**CULTURAL RESOURCES OFFICE
PRESERVATION BOARD
REGULAR MEETING
MONDAY NOVEMBER 22ND, 2010
1015 LOCUST ST. #1200
4:00 P.M.**

DATE: November 22, 2010
FROM: Jan Cameron, Cultural Resources Office
SUBJECT: Preliminary Review: install solar panels on front slope of roof
ADDRESS: 5739 McPherson Avenue
JURISDICTION: Skinker-DeBaliviere Certified Local Historic District — Ward 26

DATE: November 22, 2010
FROM: Andrea Gagen, Cultural Resources Office
SUBJECT: Preliminary Review: Install 6 awnings and 1 canopy
ADDRESS: 2001 Park Avenue
JURISDICTION: Lafayette Square Local Historic District — Ward 6

DATE: November 22, 2010
FROM: Andrea Gagen, Cultural Resources Office
SUBJECT: Preliminary Review: new single-family construction & 3 attached garages
ADDRESS: 1022 Mississippi
JURISDICTION: Lafayette Square Local Historic District — Ward: 6

EXISTING FRONT AWNINGS AND CANOPY

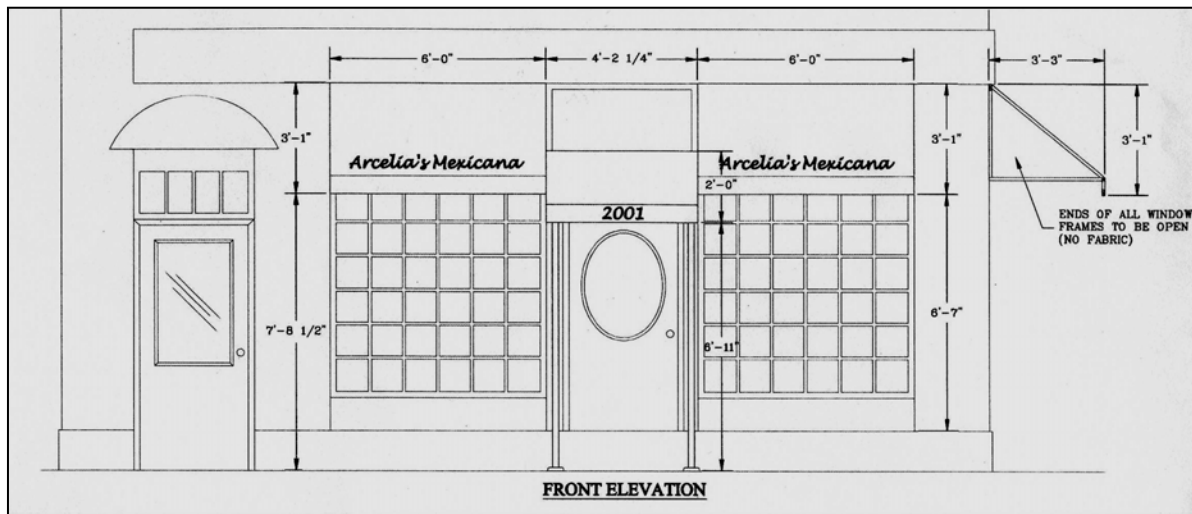
Partially complies. Most of the awnings are the same size and shape of the window behind. The canopy, however, does not cover the full opening, as the transom window above the door is exposed.

The proposed canopy does not comply with the Lafayette Square Historic District standards as no Model Example for it has been provided, and the canopy is not the same size as the opening behind it. There is also no historic Model Example for the three large side awnings with the exposed metal tubing.

PROPOSED ELEVATION OF AWNINGS AND CANOPY FROM PARK

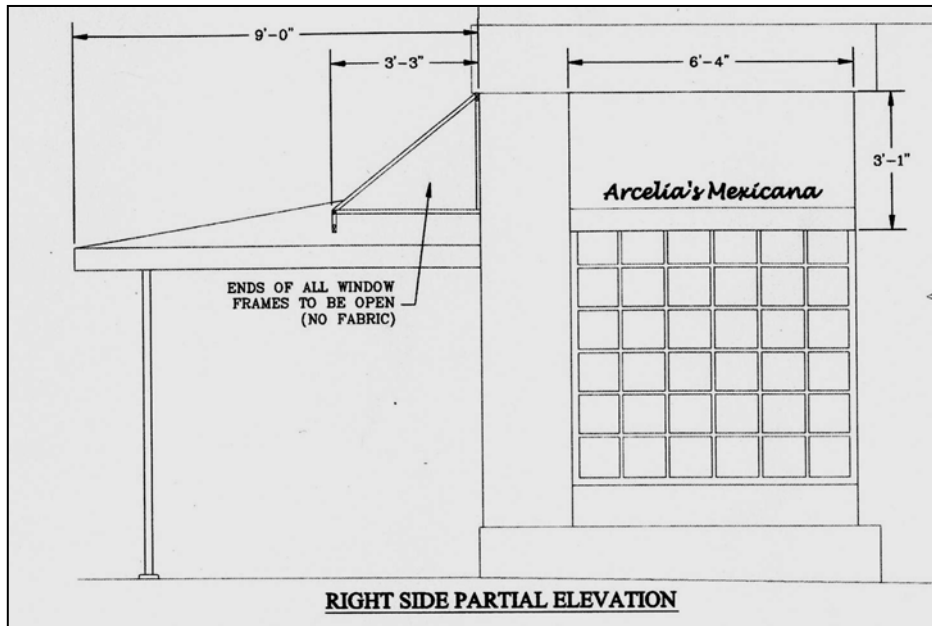
The placement of signs on the awning slope does not comply with the historic district standards. There does not appear to be any reason why the lettering cannot be on the apron of the awnings.

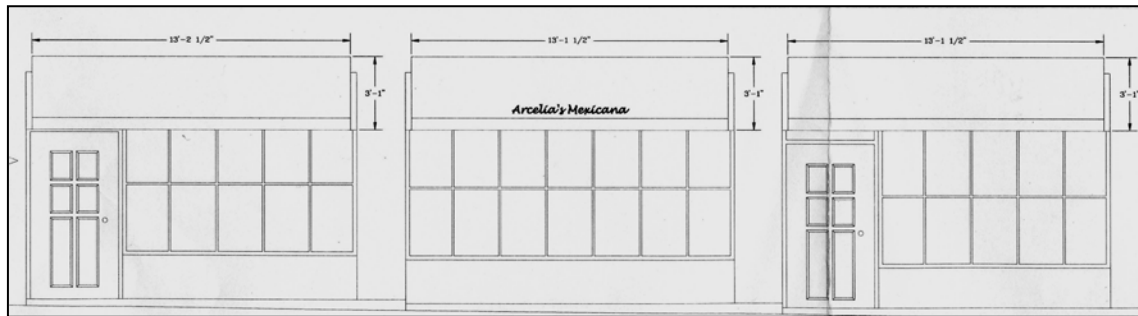
Does not comply. Signage is proposed to be on the slope of the awning.

PROPOSED ATTACHED GARAGES BEHIND 1018, 1020 & 1022 MISSISSIPPI

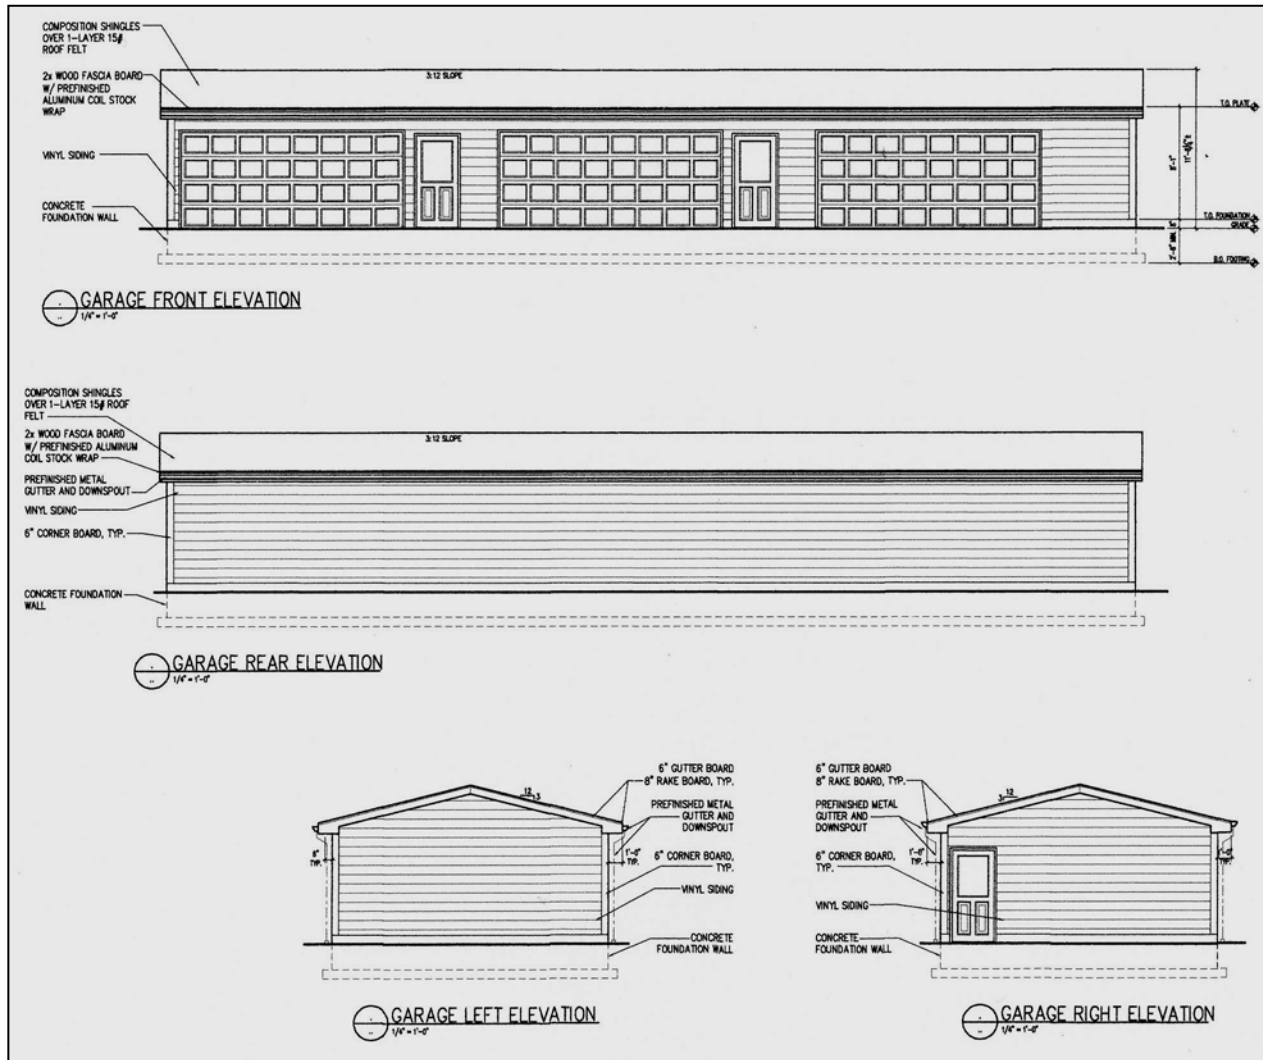
Does not comply. Since the garages are attached there are portions that are not located directly behind the main structures. These portions in the gangways between the buildings will be minimally visible. The garages also do not comply in that they are accessed from a drive at the rear of the lots and the garage doors face the buildings in front. The garage placement is complicated by the fact that there is no alley at the rear of these properties.

There has not been a detailed discussion with the applicant, but for the most part the proposed building complies with the Lafayette Square Historic District standards. The main concerns of the staff related to the main structure are the scale of the building relating to the number of stories, and the proportions of the doors and windows. The scale issue could be remedied by raising the roof height slightly and adding a dormer to make it appear that there is a third story. The doors and windows only need a slight adjustment in height and width to bring them into compliance. The garages do not comply with the standards as small sections of them will not be directly behind the buildings, and the garage doors face the rear of the buildings, not an alley.

STAIR PARTLY CONSTRUCTED

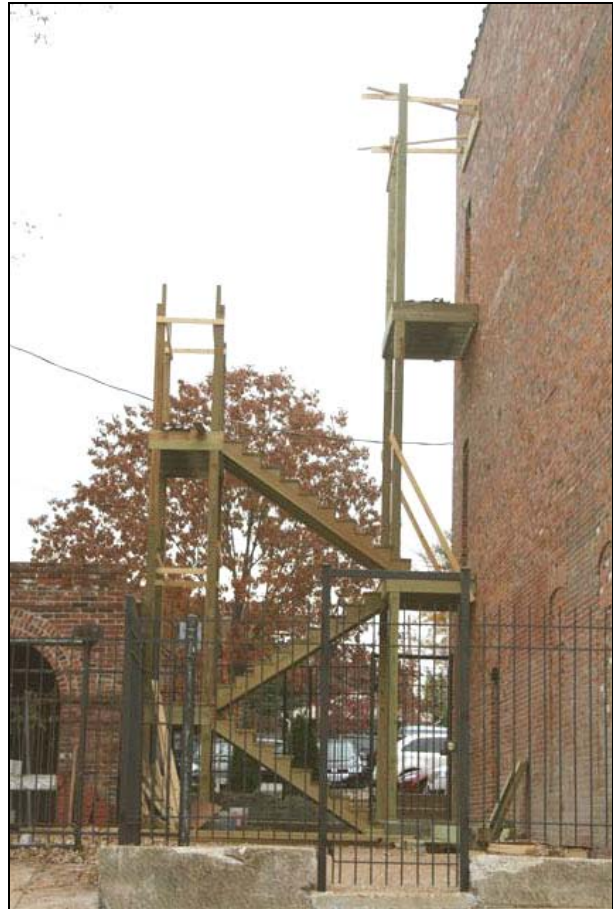
On 11/18/10, the staff met again with the developer and discussed the few available options. The developer agreed to remove the third story roof and posts; to install a Soulard handrail; to wrap exposed Womanized lumber with finish grade wood and to stain the structure with opaque stain in a dark color. He also agreed to plant tall evergreens in front of the stair to screen it as much as possible from the street.

1. That the illegal stair be modified by removing the third floor roof;
2. that upright posts be sheathed in finish materials;
3. that the entire structure be stained with an opaque stain a dark color; and
4. that tall evergreens be planted in front of the structure to screen it from street view.

EXISTING ENTRY WITH SHAKE SHINGLES AROUND DOOR

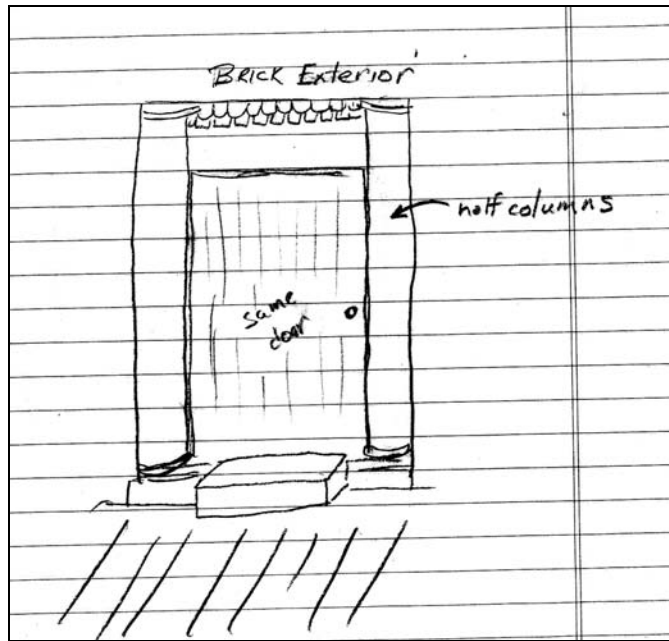
10. Architectural details on existing structures shall be maintained in a similar size, detail and material. Where they are badly deteriorated, a similar detail may be substituted. **Does not comply.** Although the original doors and transoms are being retained, the door hood is being removed. The addition of a new element on the front facade of the building also does not maintain the architectural details in a similar size, detail and material.

The door at 6178 McPherson would have originally been a large, most likely ¾-glass door which filled the opening. The applicant proposes to keep the existing door which is too small for the opening and apply trim that was not original to the house, which does not meet the Skinker-DeBaliviere Historic District standards. Although there are a few homes on the block which do have door surrounds, they are all around large, centered doors. The Cultural Resources Office has been unable to review a detailed plan of the proposed trim, as it has not yet been supplied by the applicant.
